**RE: FILE # SE 23-1127
SECOND ORDER OF CONDITIONS FOR BELLA VISTA ISLAND**

On behalf of the Applicant (U.S. Postal Service) and in accordance with the Massachusetts Wetlands Protection Act and the Town of Fairhaven Wetlands Bylaw, Gordon R. Archibald, Inc. (GRA) has submitted a Notice of Intent (NOI) for proposed pavement resurfacing and related exterior improvements at the above-referenced facility. A Public Hearing on this NOI was opened at the Conservation Commission's January 13, 2020 meeting, at which GRA provided an overview of the project, resource areas, and proposed measures to protect resources from impacts, and answered questions posed by the Conservation Agent (Staff Report dated January 8, 2020) and Commission Members. As MassDEP did not issue a file number at the time of this hearing, the NOI could not be put to vote and was continued to the next meeting date (January 27, 2020).

RE: Proposed Auto Dealership, Fairhaven, MA.
Notice of Intent / Site Plan
250 Bridge Street.

Wetland Boundary & Fencing Map 40 Wapatma Lane / Map 29, Lot 29 Fairhaven, Massachusetts		FIGURE 1
		DATE: 11-4-19	PROJECT #: W19-1241	
CREATED BY: BF		SCALE: 1 inch = 50 feet		
2014 Orthophoto

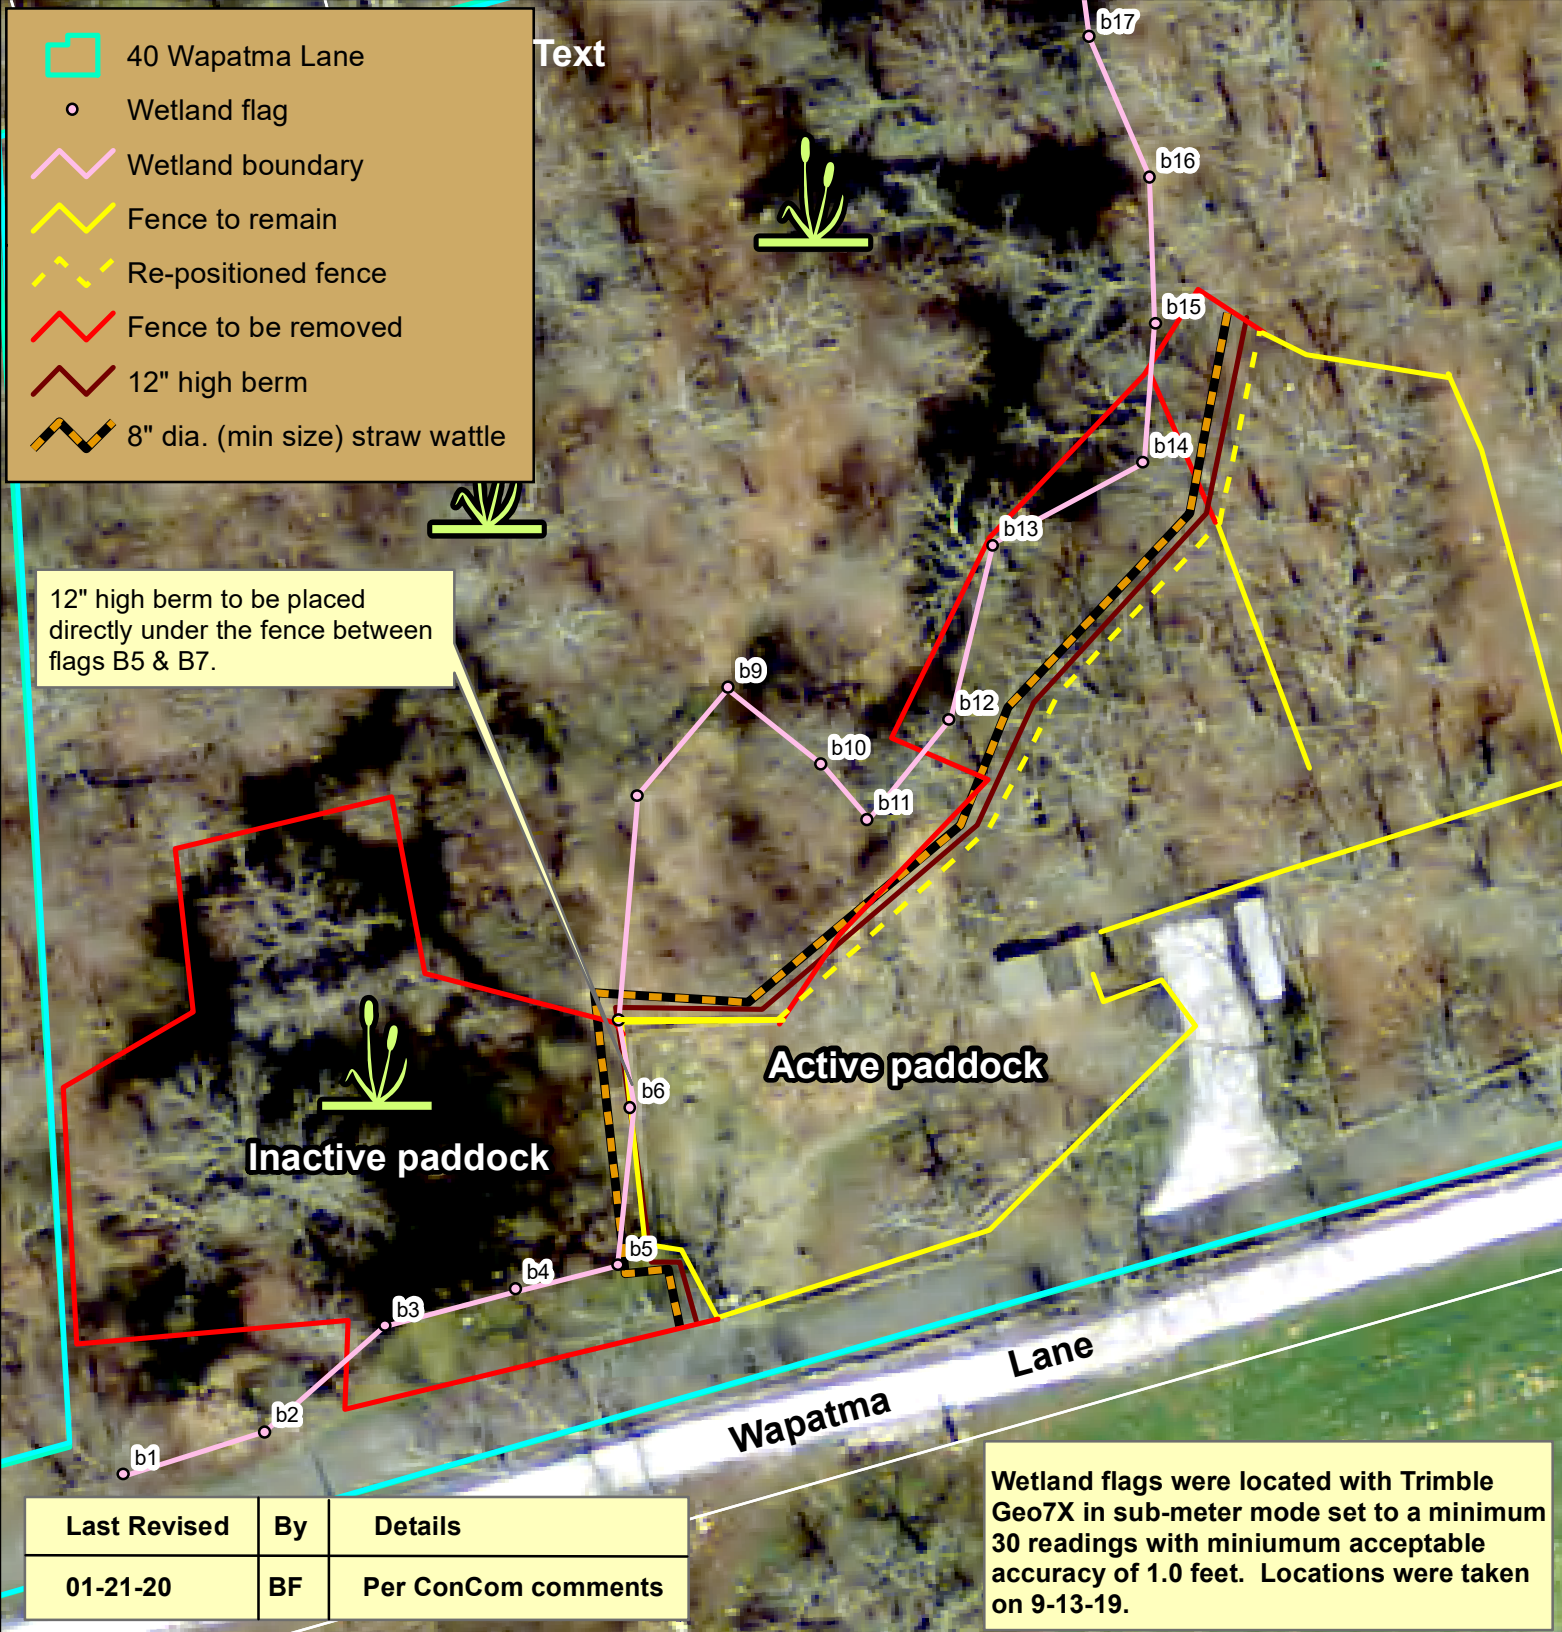
12" high berm to be placed directly under the fence between flags B5 & B7.

Last Revised	By	Details
01-21-20	BF	Per ConCom comments

C1.03 GRADING & DRAINAGE PLAN

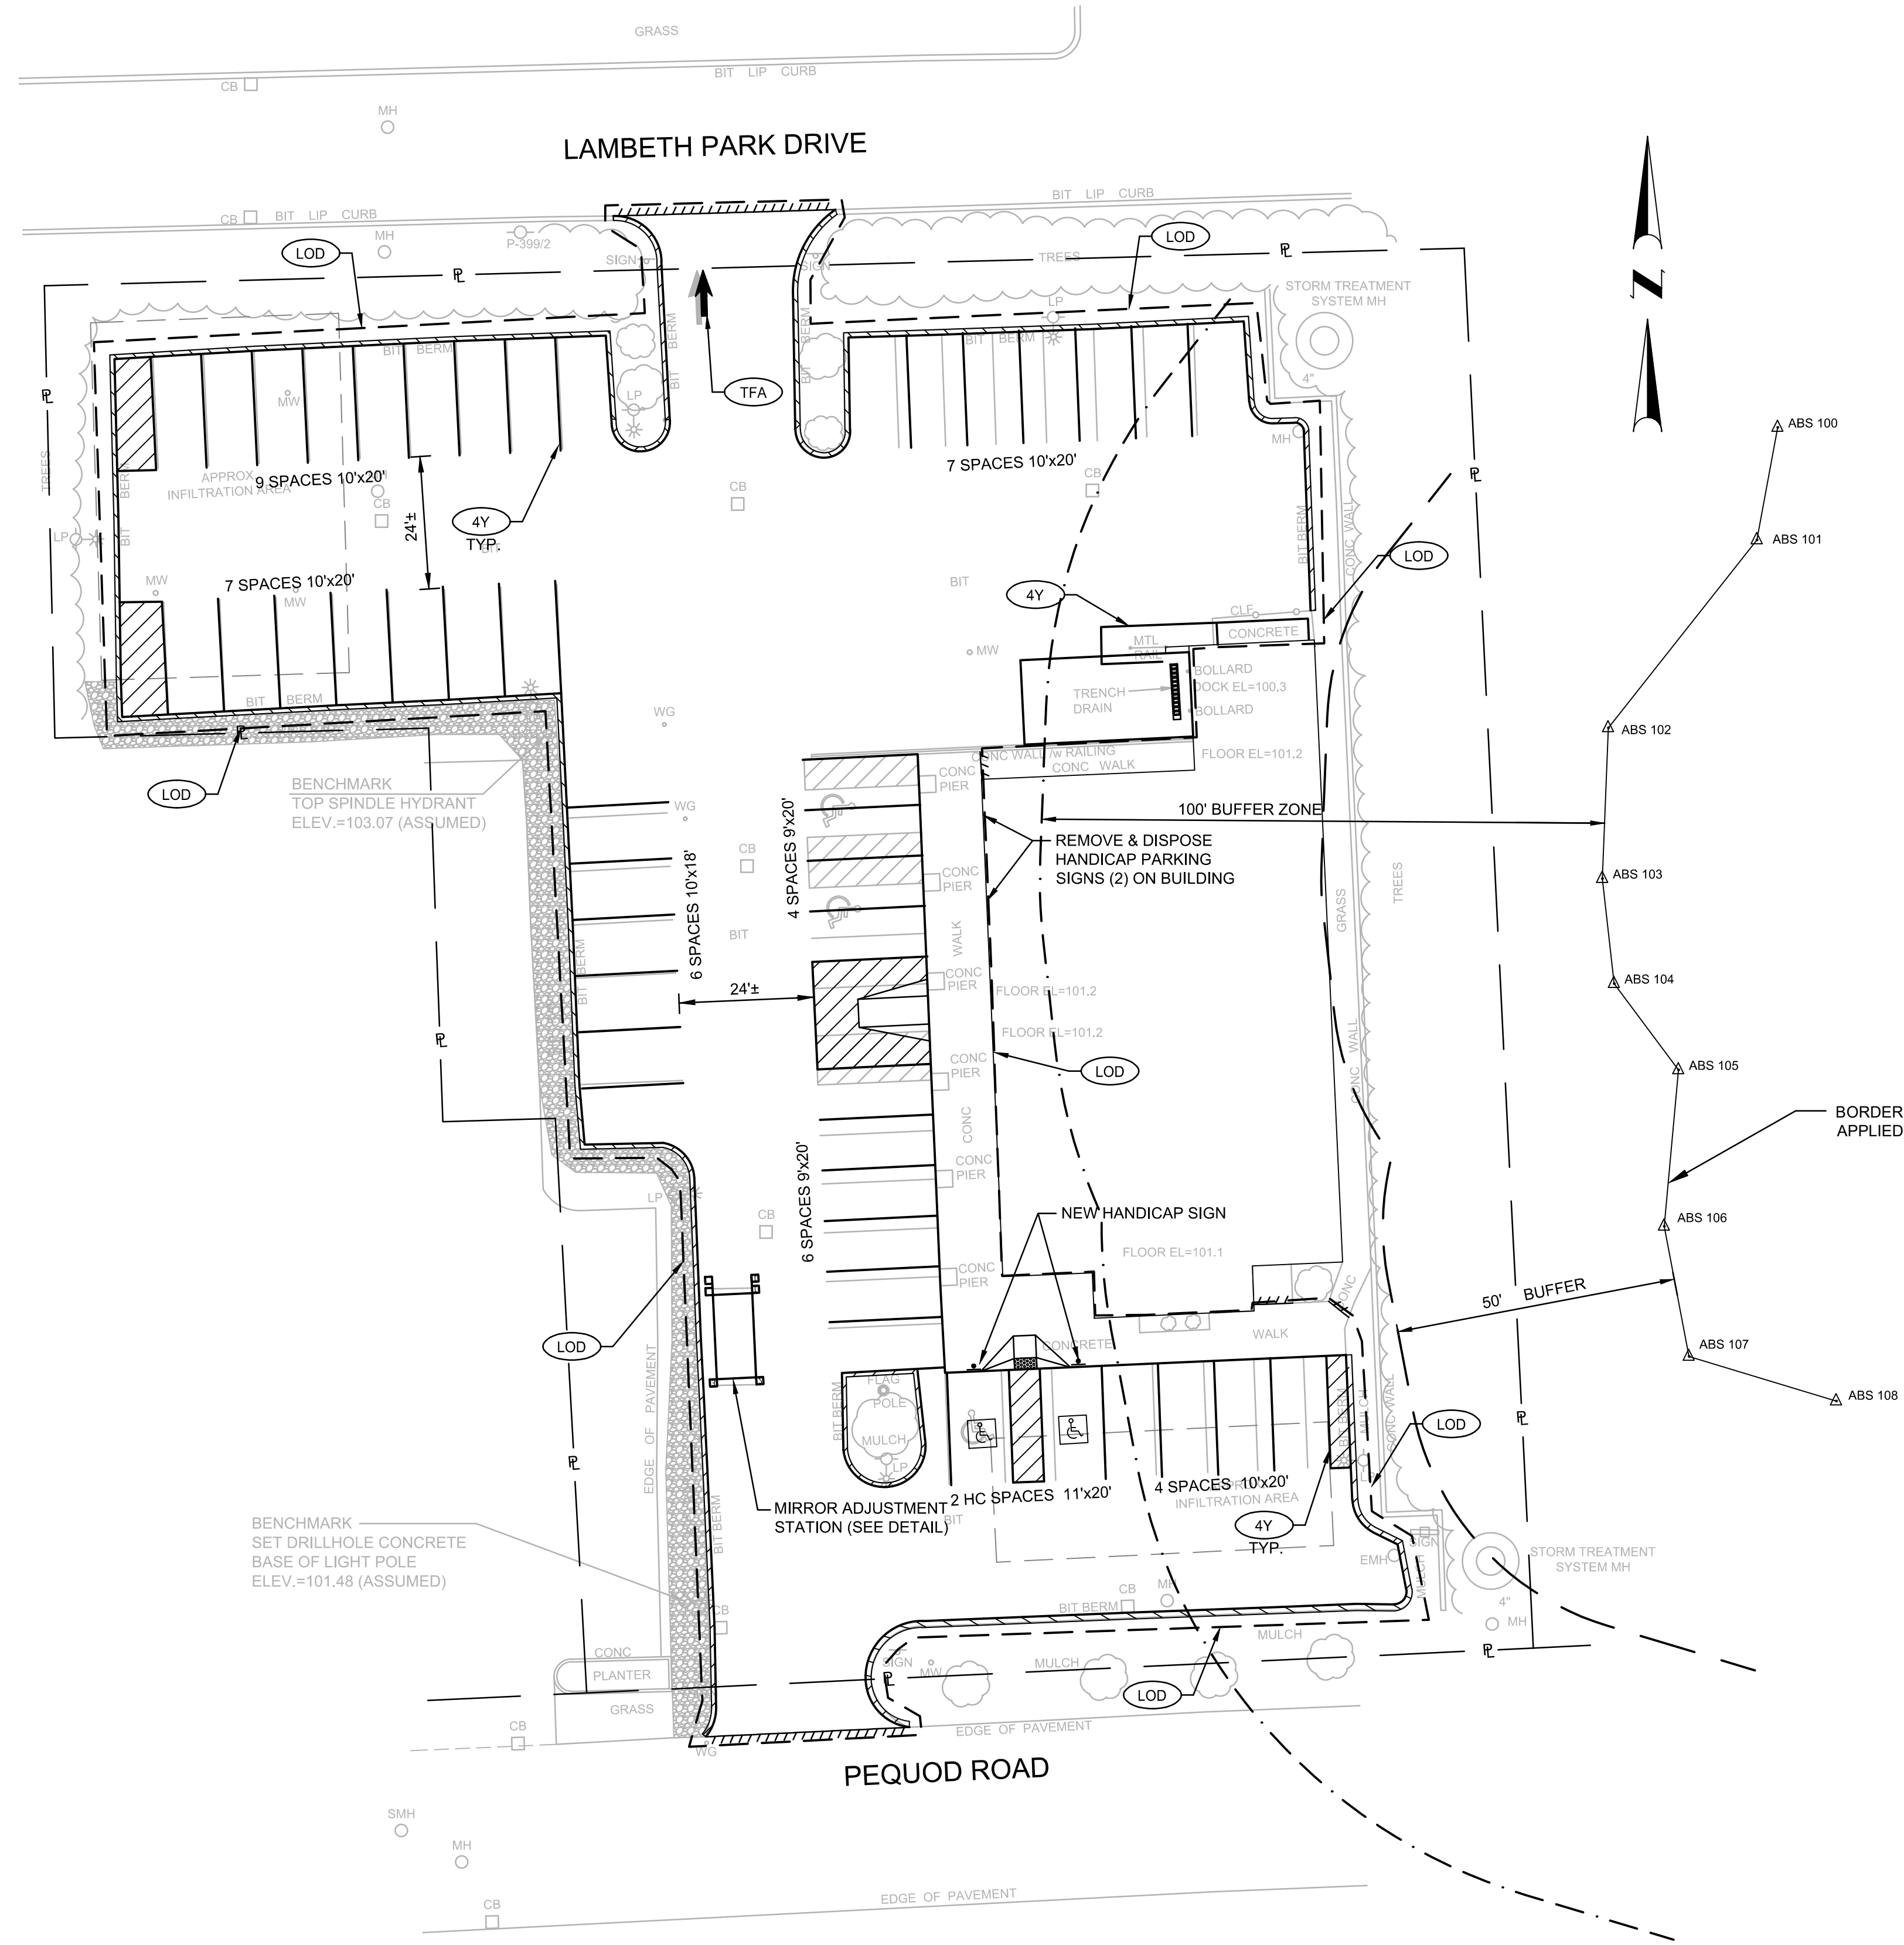
- *Question for Applicant:* Are their site constraints that prevent the use of both silt fence and compost filter sock?

Silt fence is not practicable along the portion of the site perimeter that abuts the adjacent developed property (i.e., cannot be properly installed along stone riprap slope). Silt fence has been added along the top of the wall separating the developed portion of the site from the resource area and wooded buffer below (see revised Grading & Drainage Plan, Details sheets).
